Access Compliance Report

Public Rights-of-Way

(Curb Ramps)

Intersection ID: 47404	Main Street: CYPRESS RIDGE DR	Cross Street: PENNINGER_CR	Location:	W
ADA ID: E69857DADF63	Ramp Type: Perp	Initial Pass/Fail: Fail	Overall Compliance: No	Severity Score: 37.5
Codes/Mitigation Info/Possible Solution		Field Measurements/Component Compliance

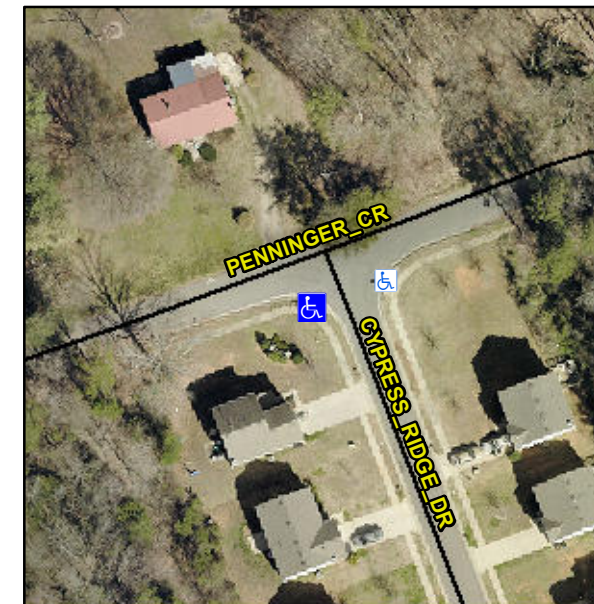
Not Found, R304.2.2, R304.5.3

Compliance	Description	Data	Compliance	Description	Data
N/A	Ramp Length (in)	48.0	No	Ramp Slope (%)	9.3
Yes	Ramp Width (in)	48.0	No	Ramp XSlope (%)	9.0
N/A	Flare Type LT	N/A	N/A	Flare Type RT	N/A
N/A	Flare Slope LT (%)	N/A	N/A	Flare Slope RT (%)	N/A
N/A	Flare Traversable LT?	N/A	N/A	Flare Traversable RT?	N/A
N/A	Landing Length (in)	N/A	N/A	DWS Provided?	N/A
N/A	Landing Width (in)	N/A	N/A	DWS Contrast?	N/A
N/A	Landing Slope (%)	N/A	N/A	DWS Length (in)	N/A
N/A	Landing X Slope (%)	N/A	N/A	DWS Full Width?	N/A
N/A	Landing Curb? (Y/N)	N/A	N/A	DWS Offset (in)	N/A
N/A	Shared Landing?	N/A			
N/A	Gutter Ponding?	N/A	N/A	Gutter Slope (%)	N/A
N/A	Gutter Lip Ht (in)	N/A	N/A	Gutter X Slope (%)	N/A
N/A	Painted X Walk1?	No	N/A	Painted X Walk2?	N/A
	X Walk 1 Direction	To E		X Walk 2 Direction	N/A
N/A	X Walk 1 Width (in)	N/A	N/A	X Walk 2 Width (in)	N/A
	X Walk 1 Slope (%)	5.3		X Walk 2 Slope (%)	N/A
	X Walk 1 X Slope (%)	6.1		X Walk 2 X Slope (%)	N/A

Remove & Replace Entire Ramp.
